UNITED STATES PATENT AND TRADEMARK OFFICE

APPLICATION NO.	FILING DATE	FIRST NAMED INVENTOR	ATTORNEY DOCKET NO.	CONFIRMATION NO.
10/587,367	04/26/2007	Dieter Ramsauer	135408-2036	8433

Office Action Summary	Application No. 10/587,367	Applicant(s) RAMSAUER, DIETER	
	Examiner KRISTINA R. FULTON	Art Unit 3673

DETAILED ACTION

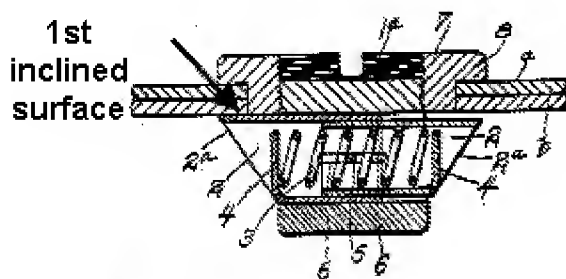
1. Claims 23, 26, 29-30 are rejected under 35 U.S.C. 102(b) as being anticipated by (Witzberger US 1426239).
2. Regarding claim 23, Witzberger teaches a snap fastening suitable for mounting in a thin wall (plates a,b) having a head part (8) arranged on one, outer side of the thin wall which overlaps an outer rim of the opening, a body part (1) which projects through the opening in the mounted position, holding elements (2) which project from the body

part and are resilient in a direction of the body part's outer surface against a spring force (3), a free end of the holding elements being provided with a first inclined surface (see figure below – Please note that “inclined” is defined as “tending in a direction that makes an angle with anything else” –source: Dictionary.com. Therefor without a reference the surface as labeled below can be considered inclined. Further, please note that if applicant intended to claim that the surface is inclined with respect to the wall; please see applicant's provided art 883121 where surface 22 is at an incline. Please note that 883121 is used for support and is not part of the rejection) for supporting the body part without play on the rim wherein the first inclined surface rests on the rim of the opening in the mounted position wherein said free end of said holding elements being further provided with a second inclined surface (2a) for slam action, said body part, holding element and spring generating the spring force being separate parts; wherein the holding elements are slides displaceable in the cylinder of the body part parallel to the plane of the thin wall; the slides are held against a pressure spring force (3) by a hook arrangement (slots 6 hook onto pin 5).
